September 14, 2015
ADDENDUM #2 to Bid Documents for the
Hidalgo County Regional Mobility Authority
US 281/BSIF CONNECTOR PROJECT CONTRACT NO. 0220-01-023, Etc.
Advertised August 2, August 9, and August 16, 2015

BACKGROUND ON THE CHANGES TO BID DOCUMENTS

ADDENDUM # 2 - PLAN SHEETS MODIFICATION SUMMARY

CONT	SECT	JOB	HIGHWAY
0220	01	023, ETC	US 281
DIST	COUNTY	SHEET NO.	
PHR	HIDALGO	175

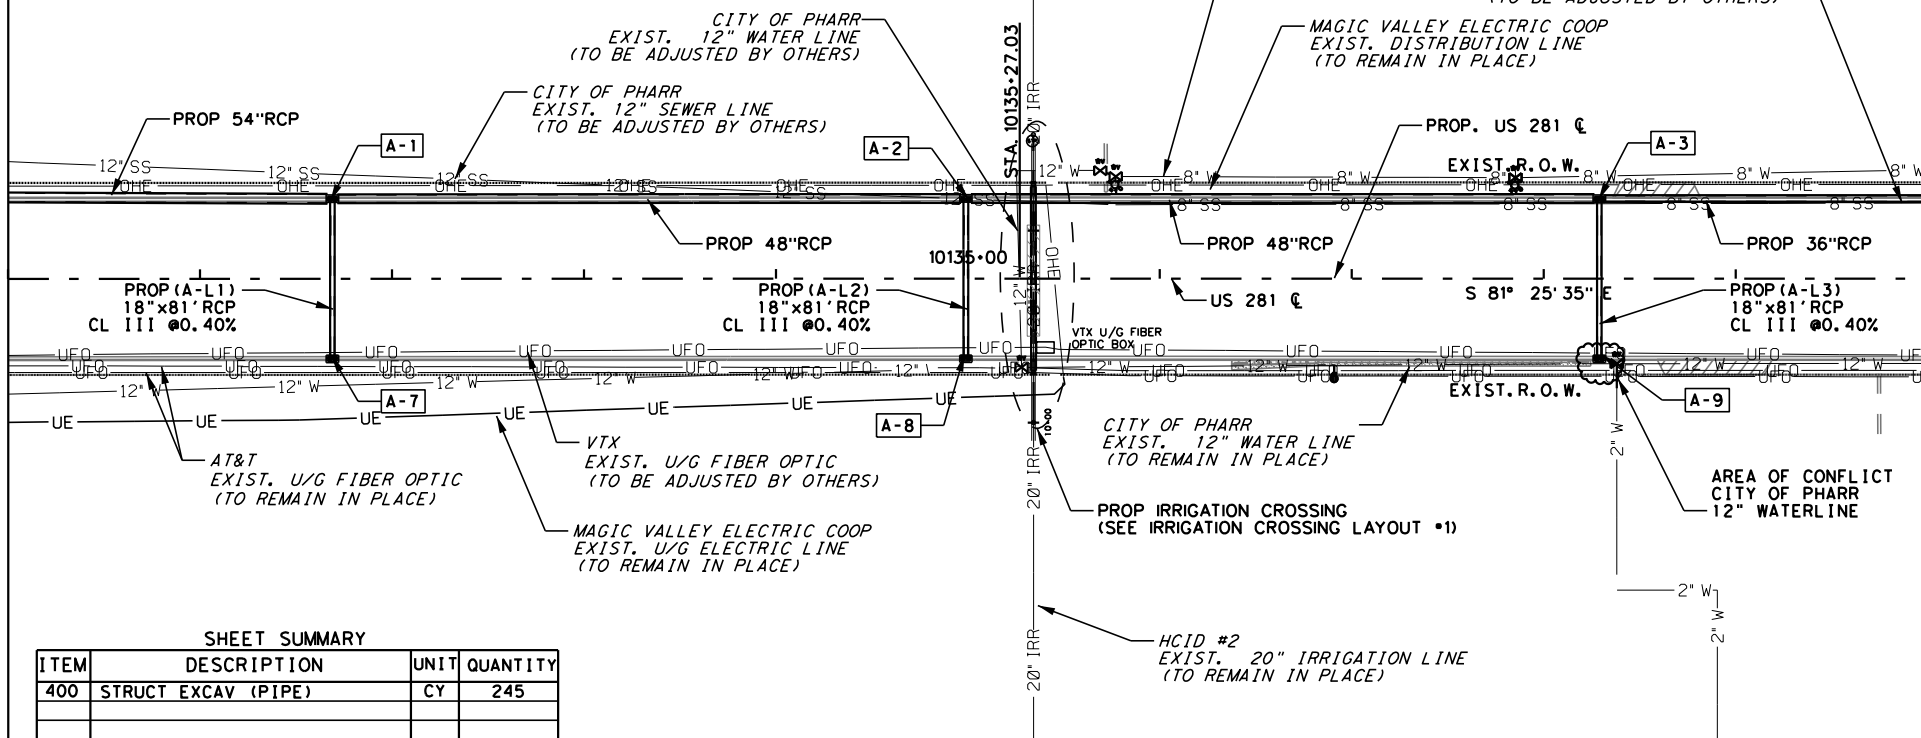
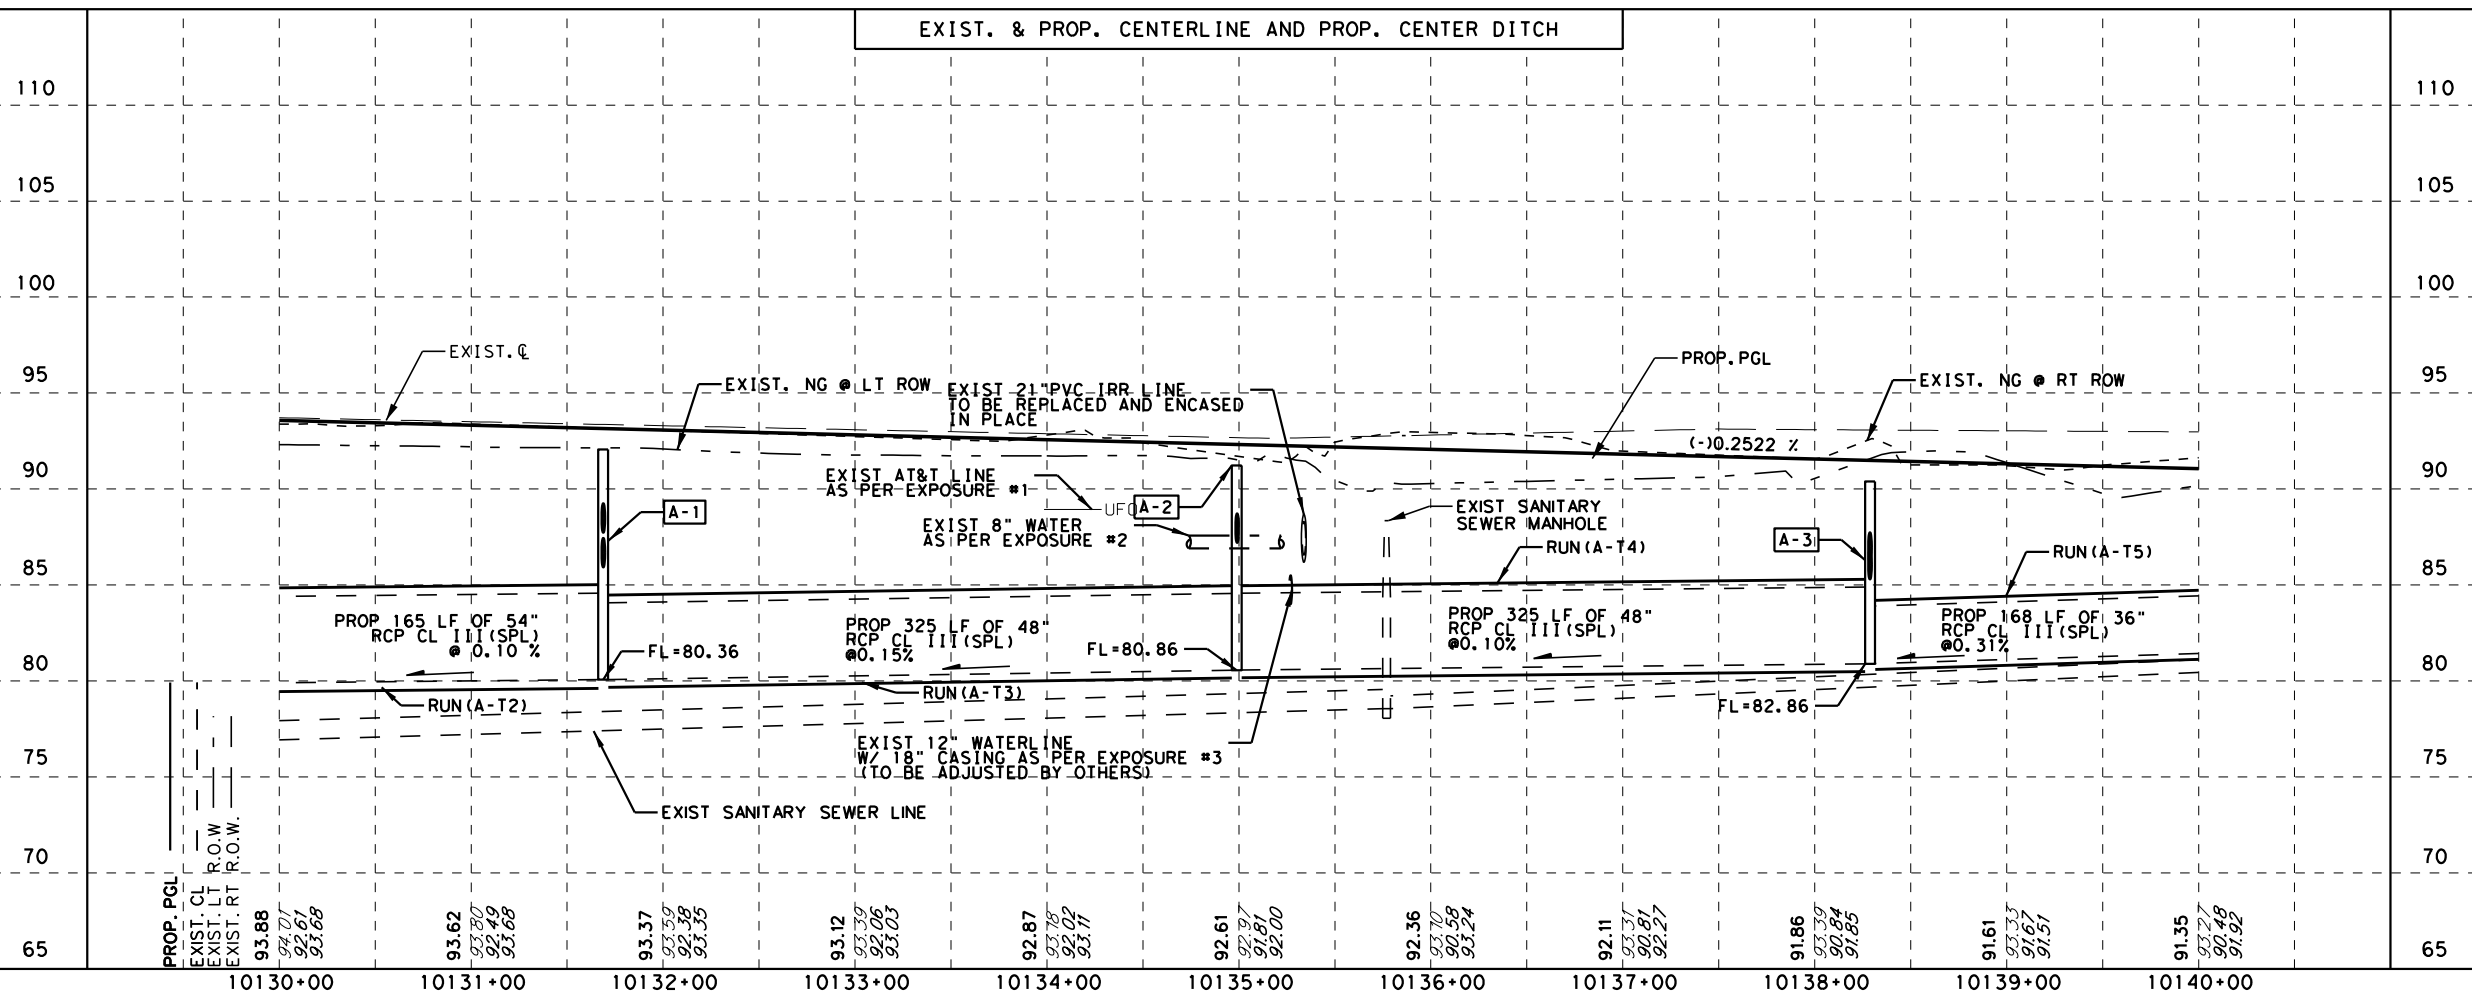
ITEM 400-6003 Structural Excavation (Pipe) will added to Sheets 175,176

DN:		CONT	SECT	JOB	HIGHWAY
CK DN:		0220	01	023, ETC	US 281
DN:					
TR:		DIST	COUNTY		SHEET NO.
CK TR:		PHR	HIDALGO		179

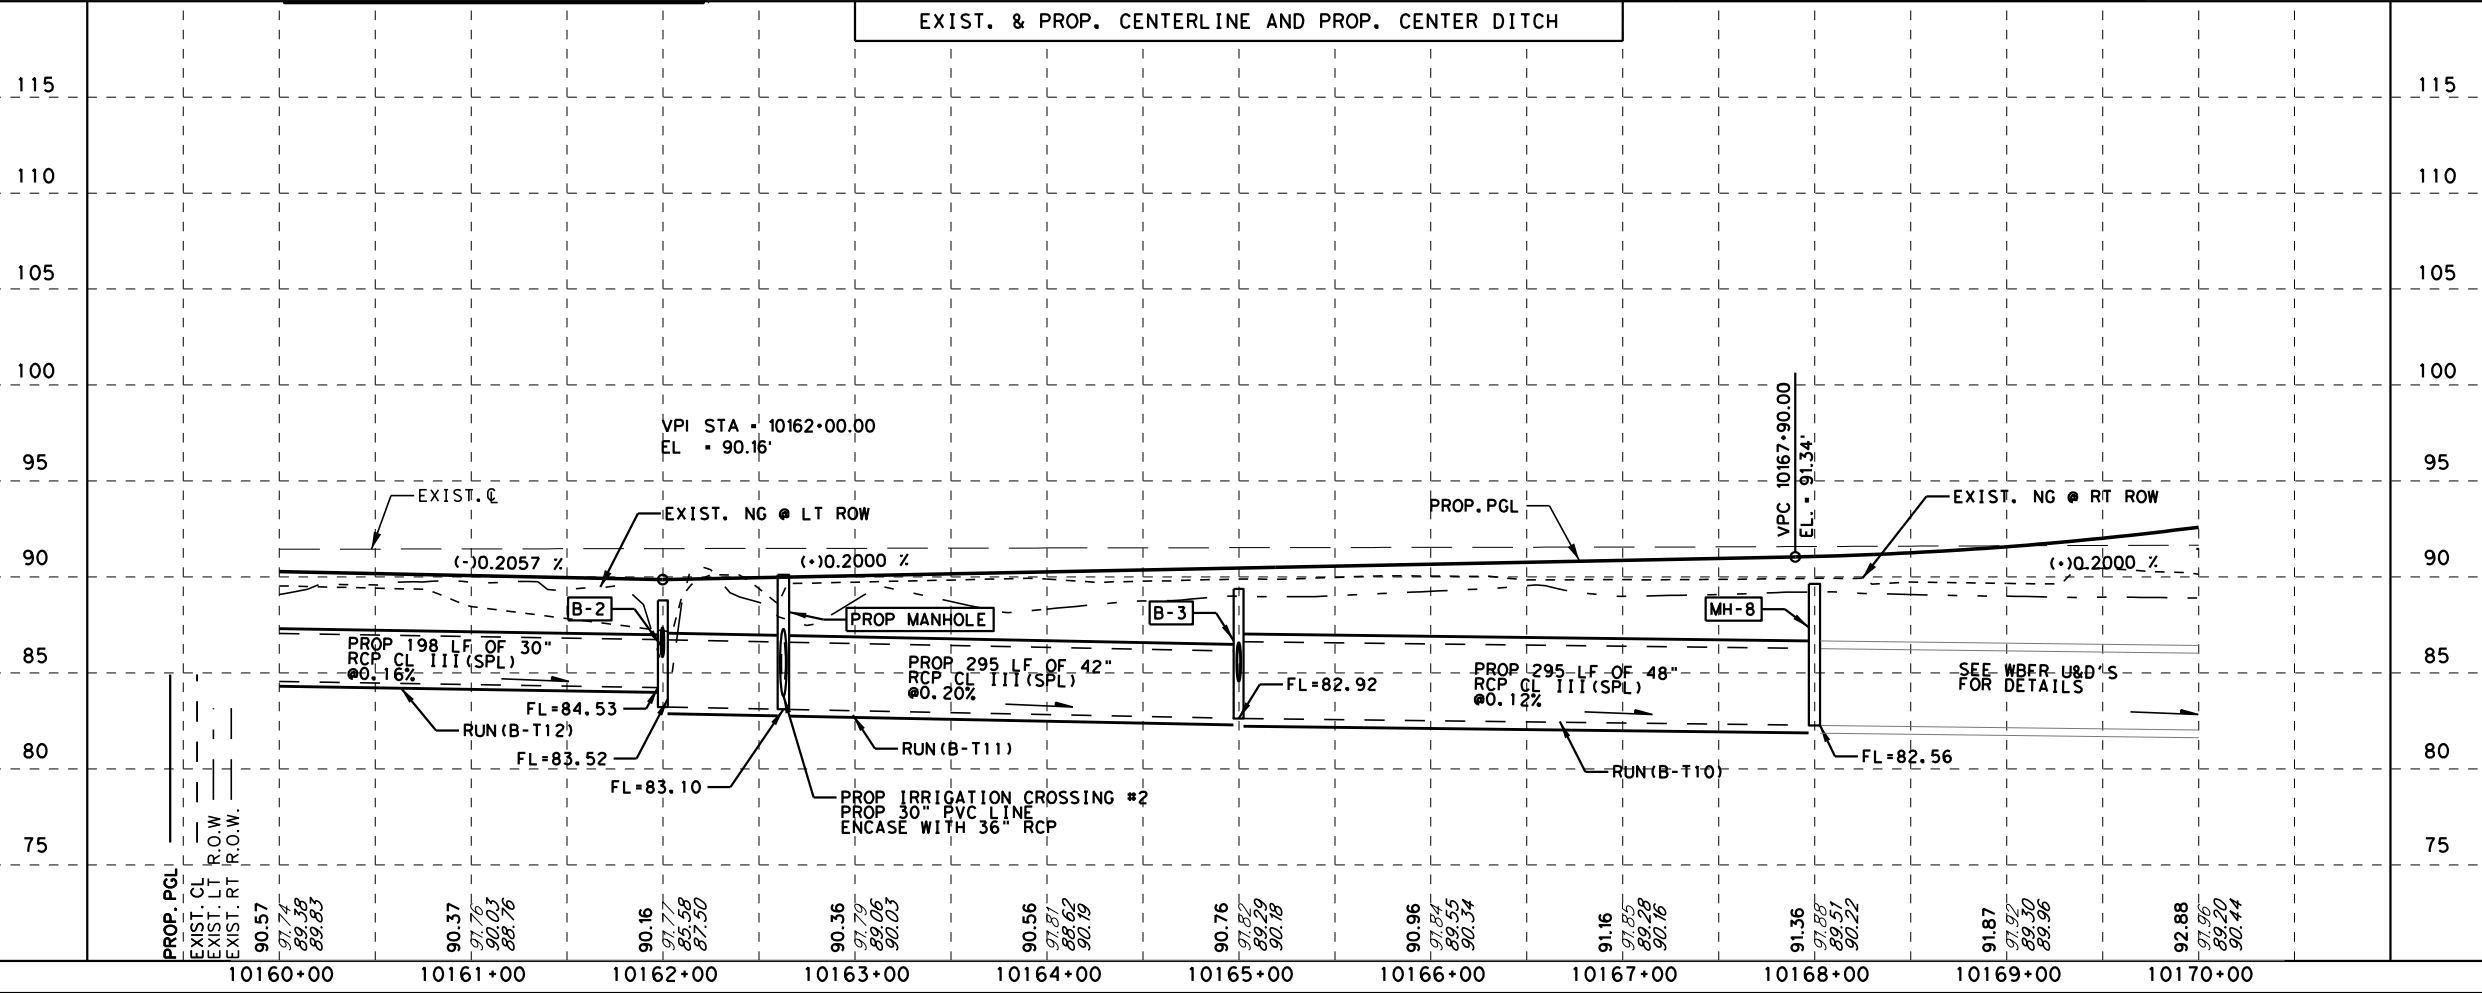
Due to Irrigation Crossings a Manhole was added to U&D's layout 179,182,184,&193
